August 19, 2020

RE: 1901 N. AMERICAN STREET CDR SUBMISSION  
RESPONSE TO CDR COMMENTS

# SITE CONTEXT

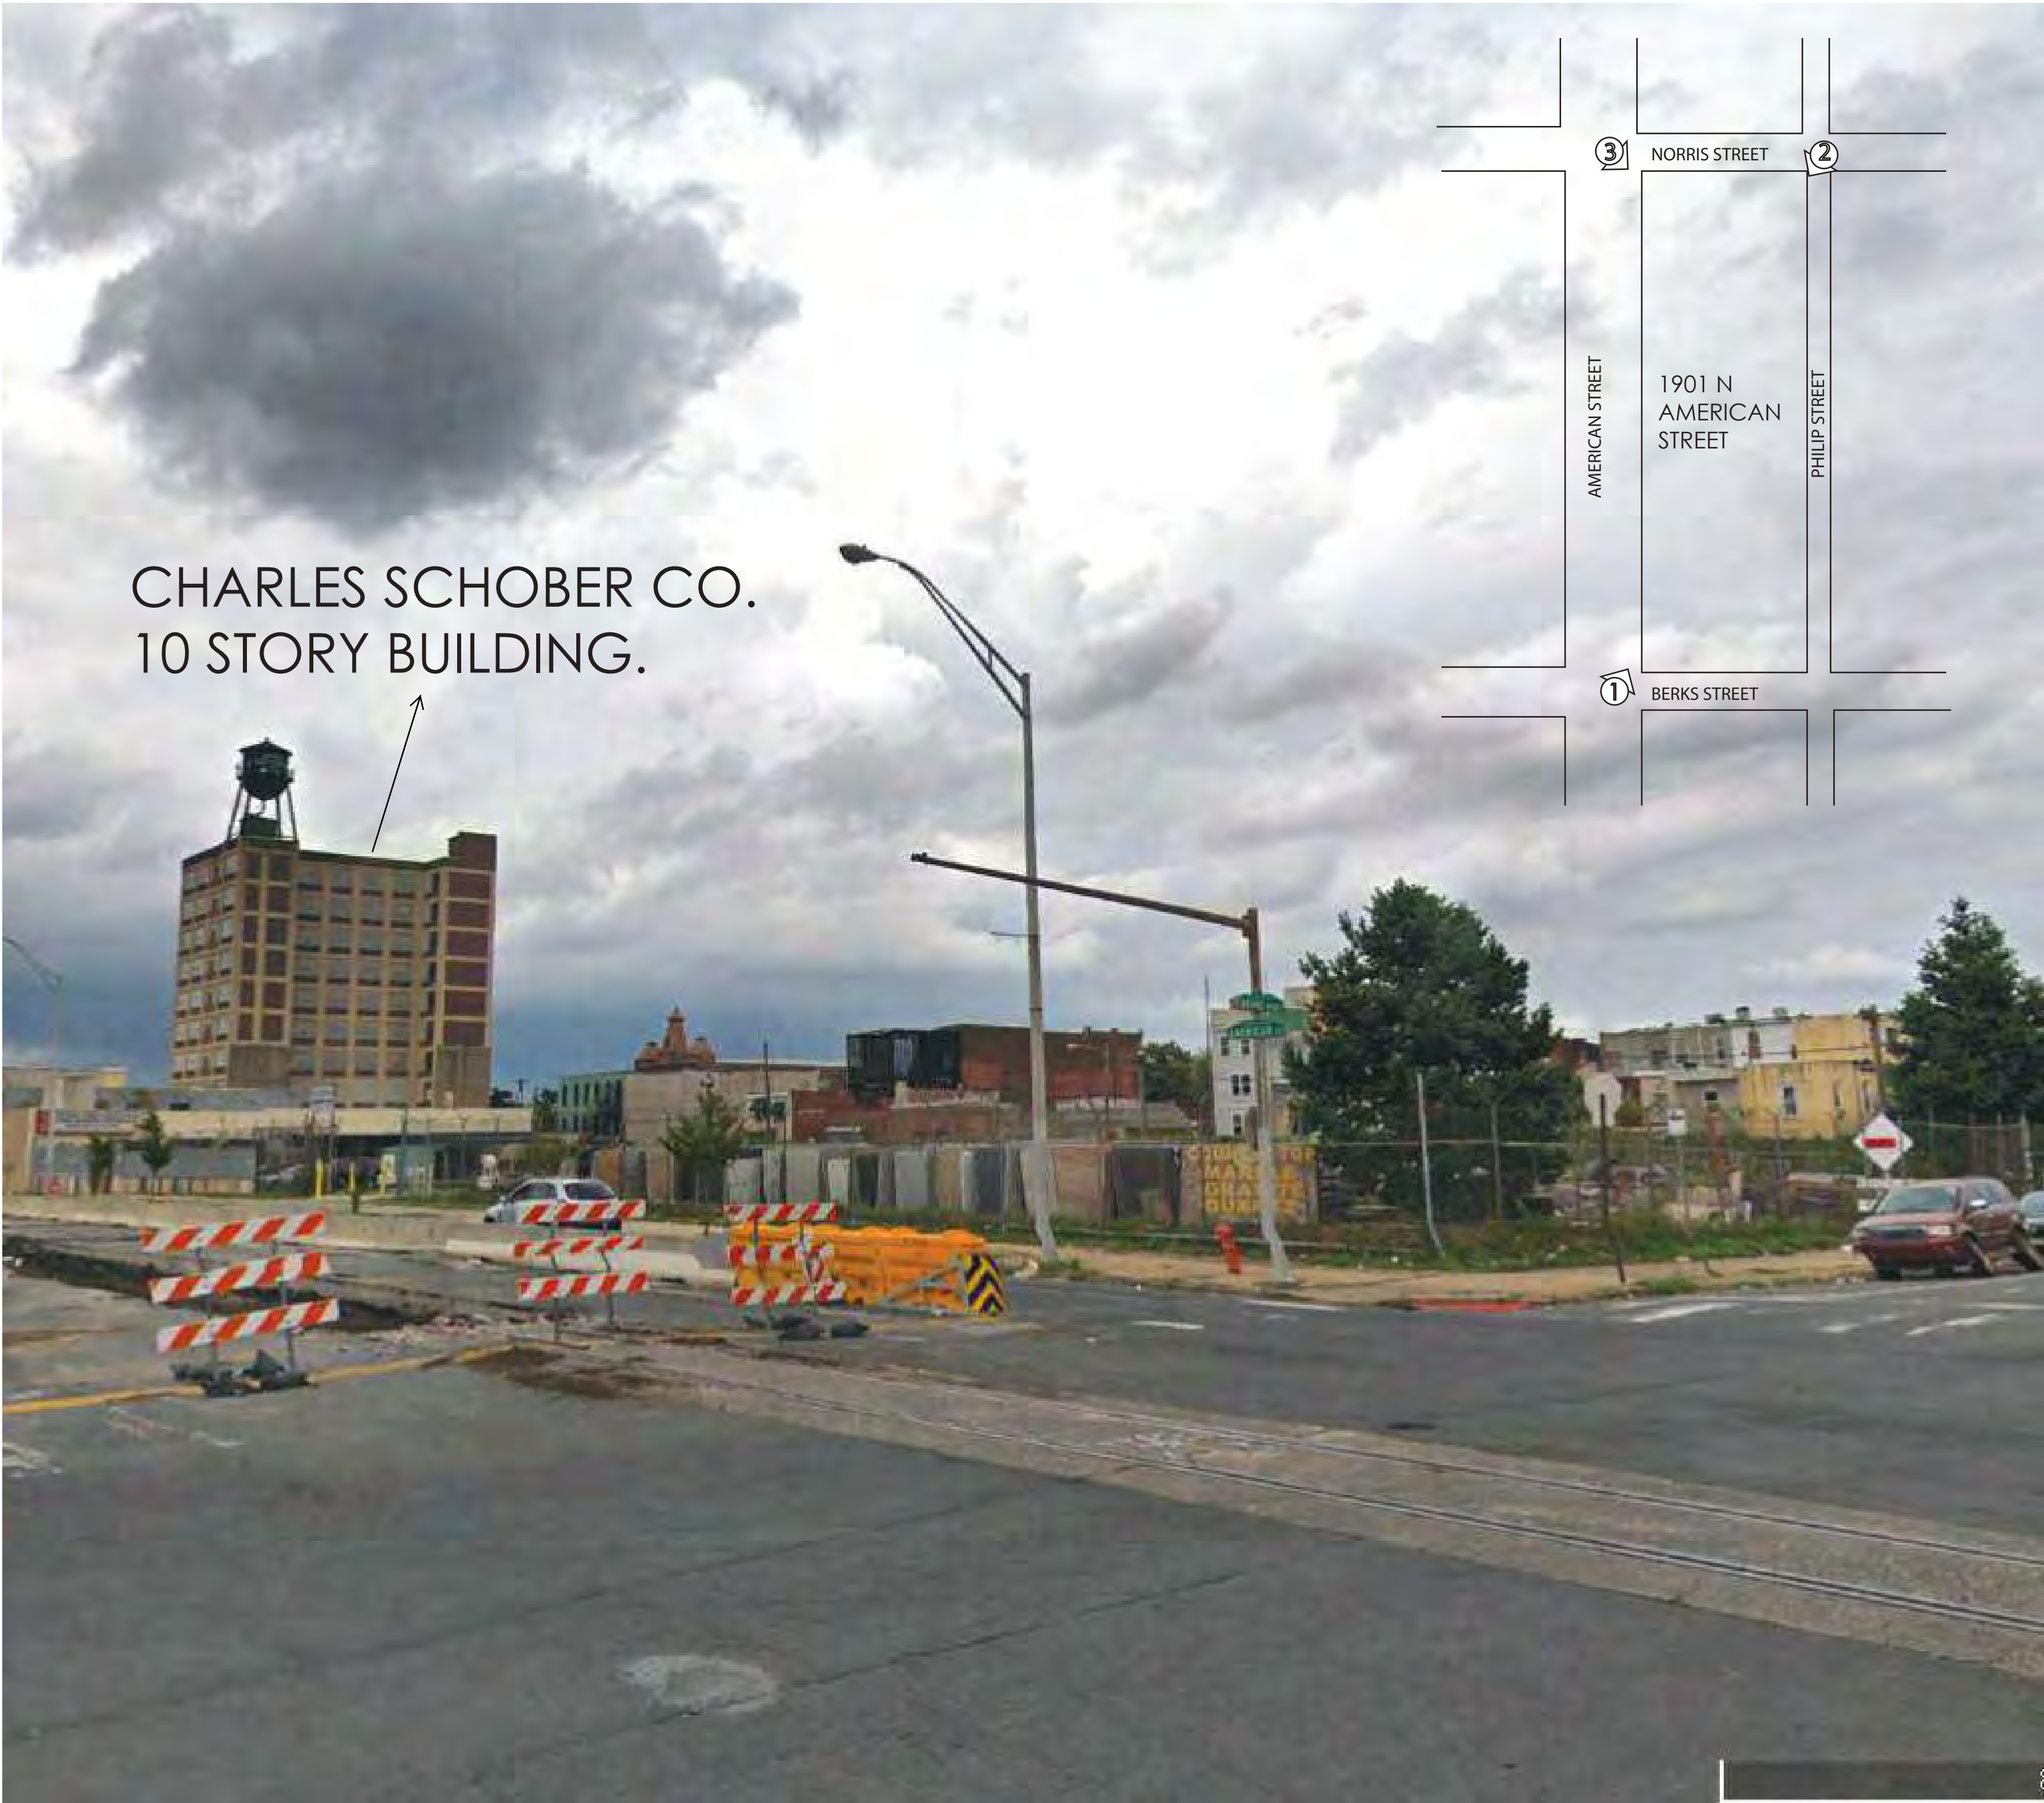
### **1. CDR: The proposal appears to be out of context with the surrounding blocks.**

RESPONSE: We have added massing models that show the surrounding buildings and the relationship of the proposal with the existing neighborhood context. This part of Norris Square is experiencing a large amount of new multi-family density and commercial activity. Our proposal is responsive to that fact while being cognizant of the existing smaller scale development on neighboring Philip Street, as evidenced by the open-air courtyards and setback balconies included along the Philip Street side.

CAR  
CIRCULATION  
PLAN

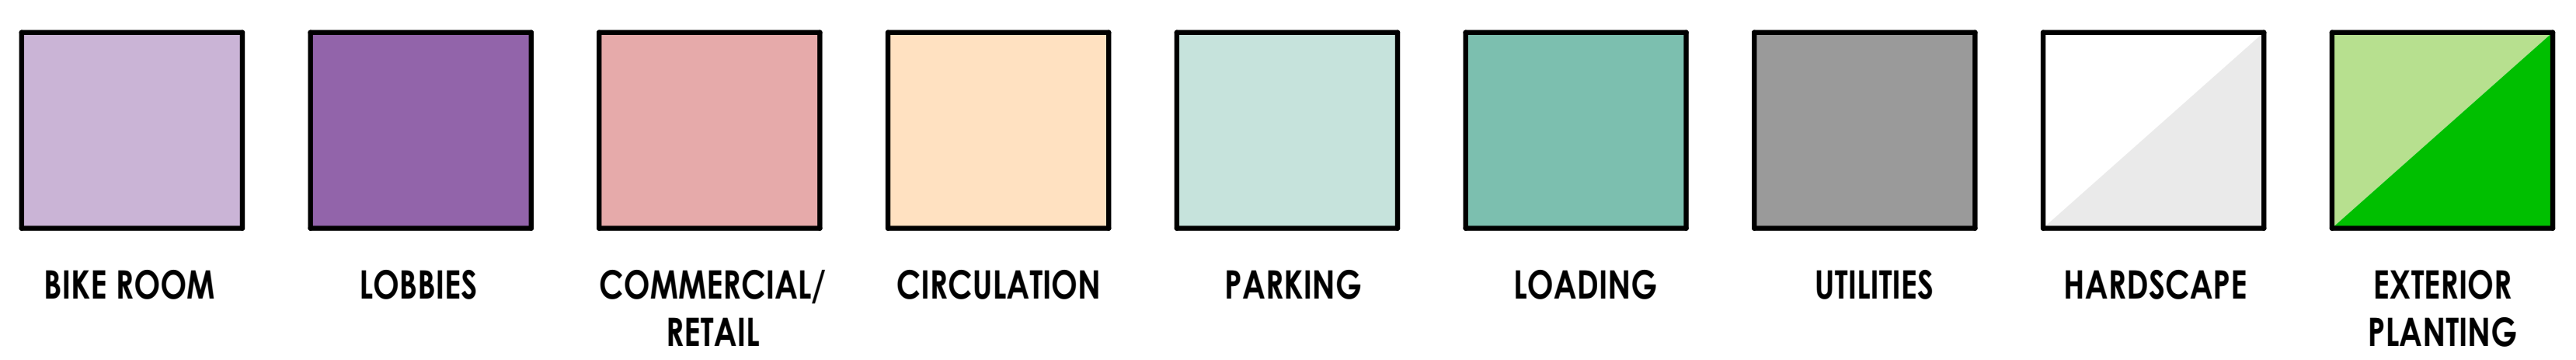
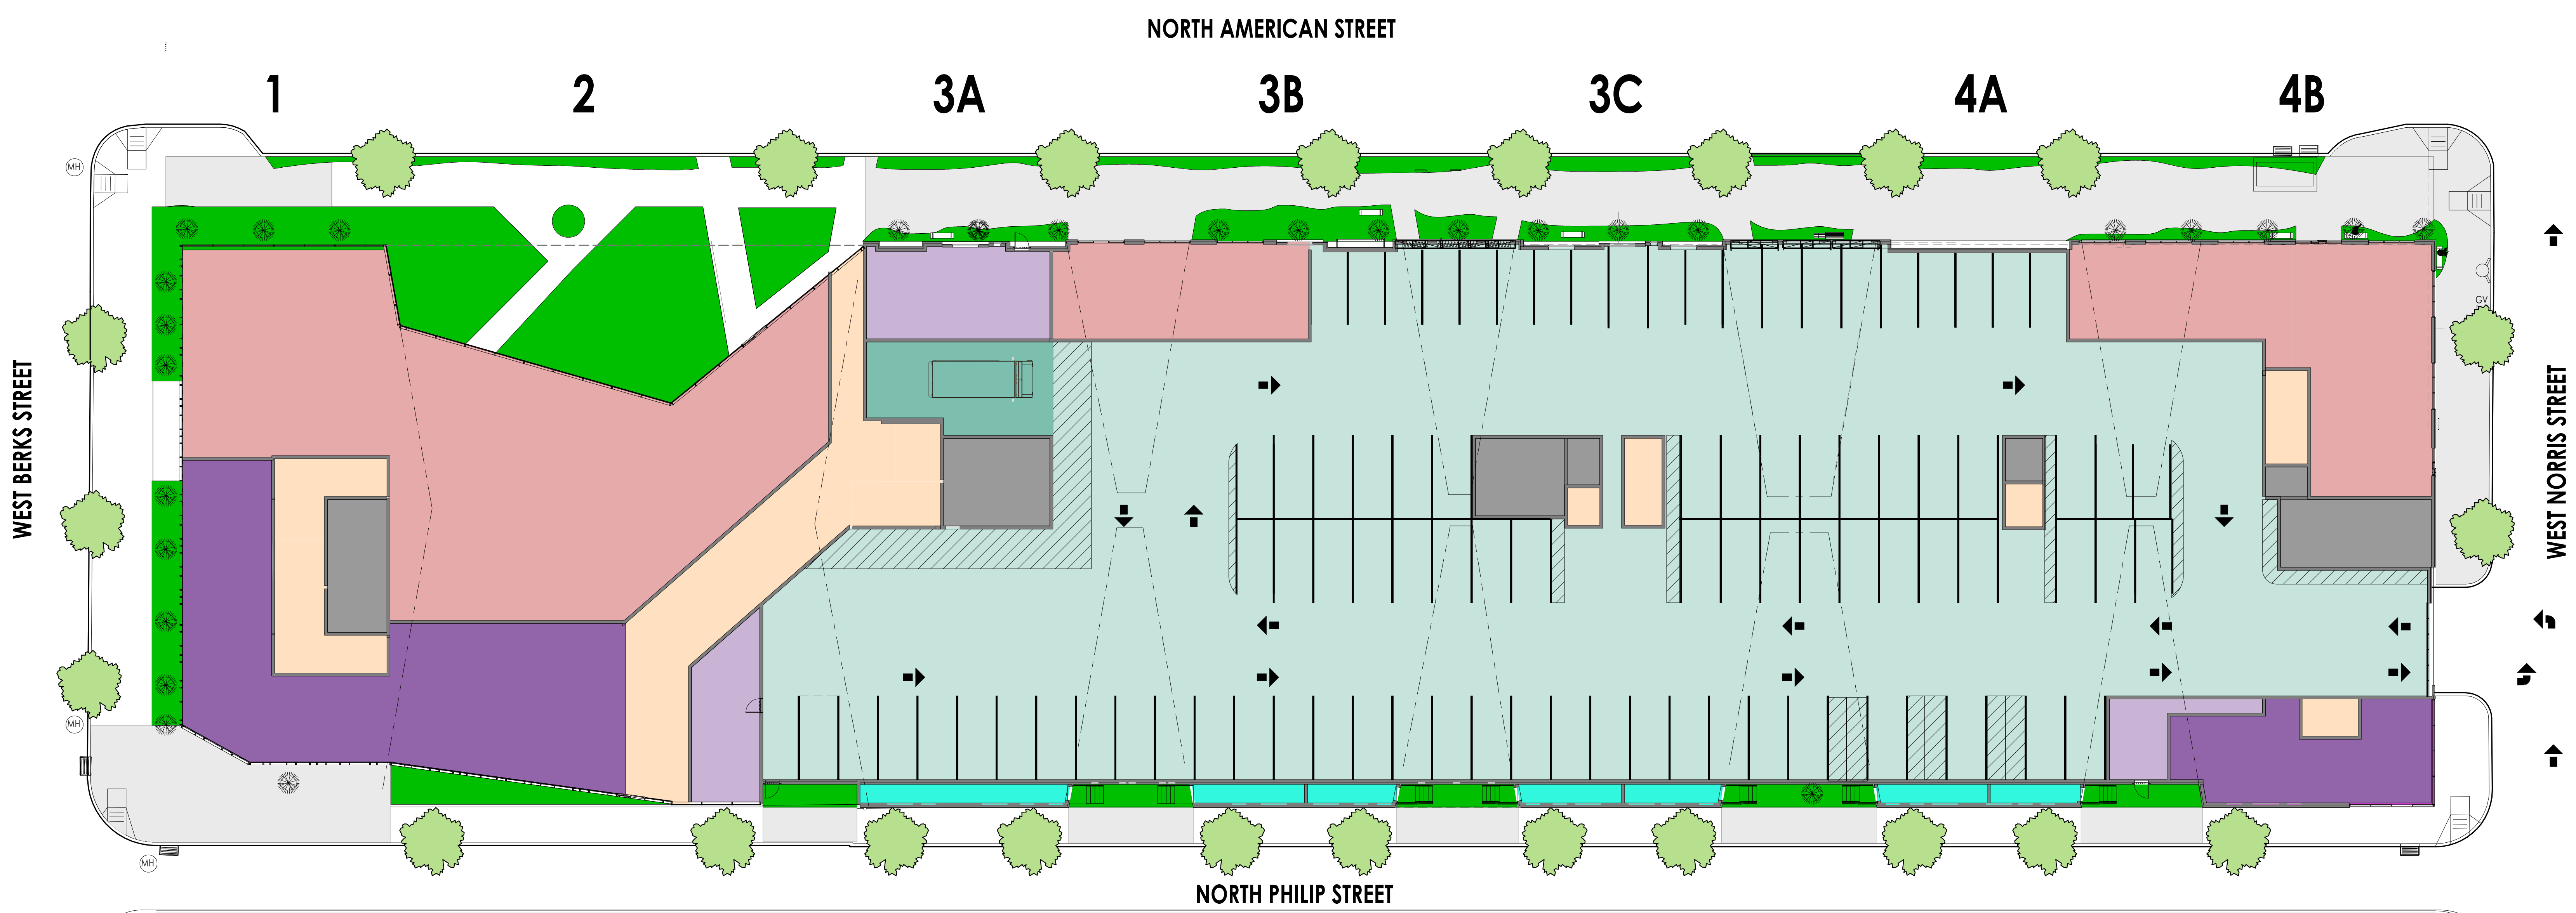
- 14. CDR: Please indicate what size trucks will be servicing the building and whether they can turn into/out of the site.**

- 15. CDR: Please show how/where emergency vehicles will enter and exit the site.**

RESPONSE: We propose to provide adequate space for standard front-loading trash trucks , including standard turning radii and ceiling heights (15 ft). We have also added a truck circulation diagram as part of our revised presentation materials.

RESPONSE: We have provided emergency vehicle access on Norris Street.

FIRST FLOOR PLAN

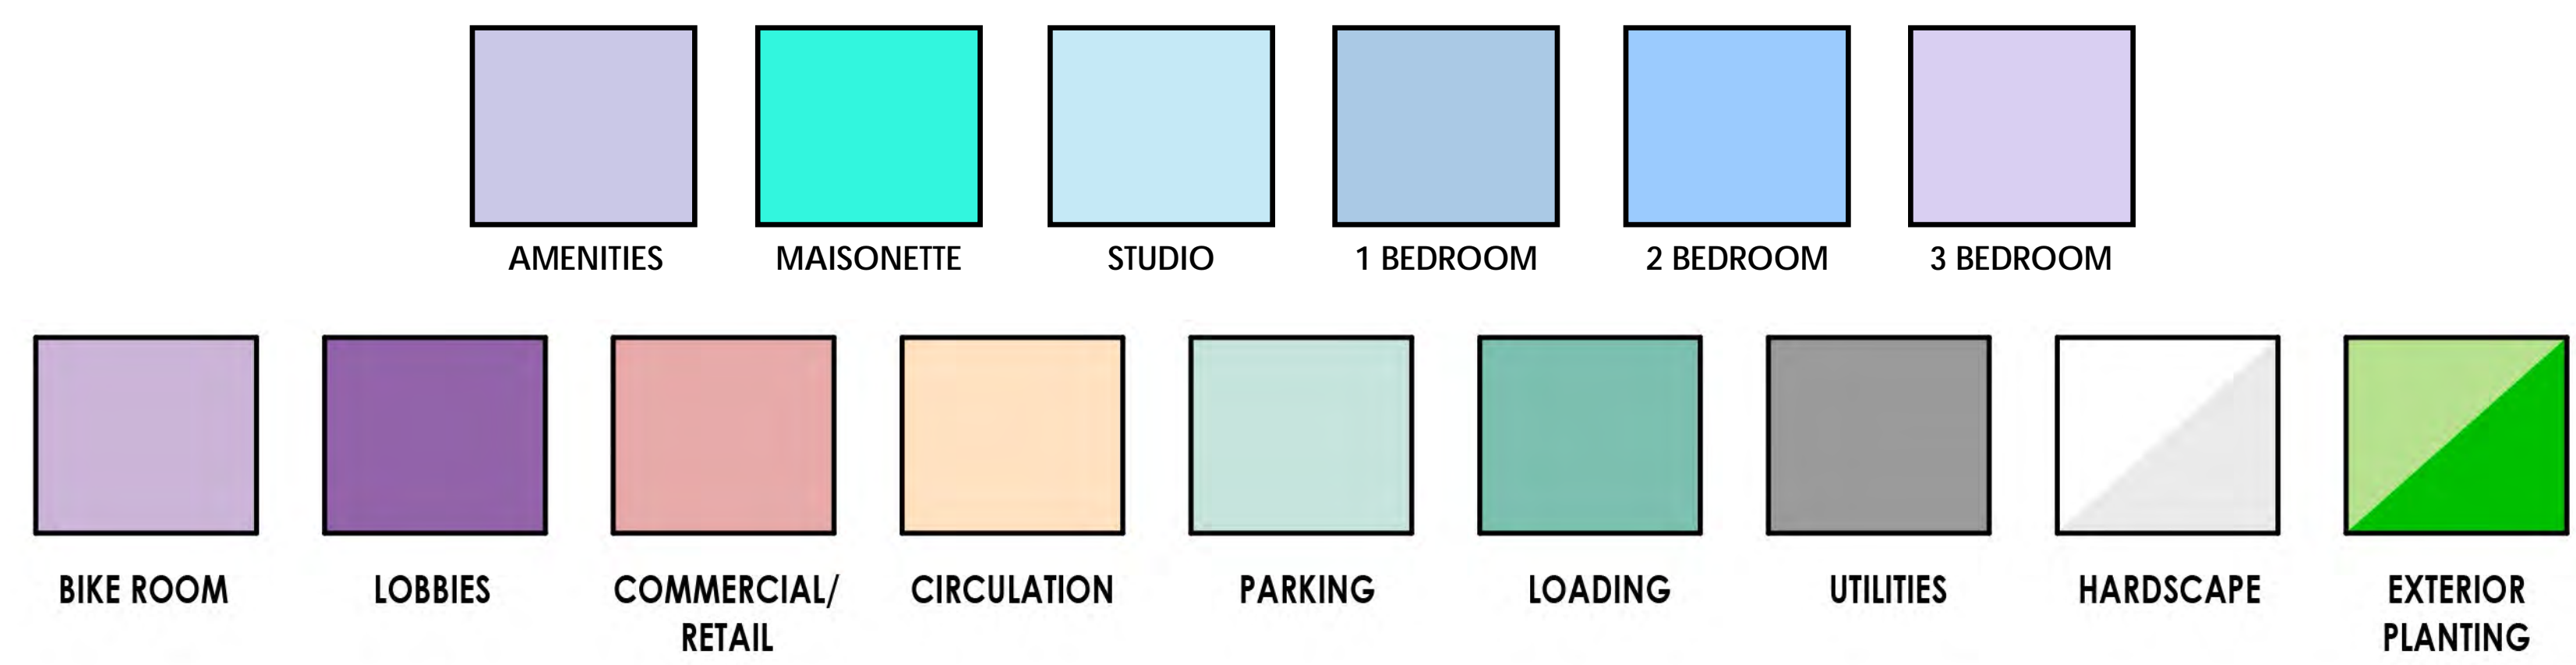
### **4. CDR: Being able to move back and forth across that parking lot seems important.**

### **5. CDR: We can't quite get a grasp of how this building is serviced.**

- 13. CDR: The bicycle parking spaces in the garage must be accessible to riders using N. American Street. Please indicate what route they will take. Staff are concerned that cyclists will conflict with dumpsters and vehicles entering and exiting the garage.**

RESPONSE: We have revised the first-floor plan to illustrate the simple and safe circulation path that allows pedestrians to safely avoid the traffic lanes of the proposed parking garage while still allowing for direct access to bike rooms and other amenity spaces located on the first-floor for the residents.

RESPONSE: We have revised the ground floor plan to clearly identify the building service and parking entrance on Norris Street. The previously shown entrances on Philip Street and N. American Street have been removed. Vehicular movements are also clearly delineated on the revised plan.

RESPONSE: We have updated the ground floor plans to illustrate accessible routes to all of the proposed bike parking spaces within the building as well as direct access to North American Street.
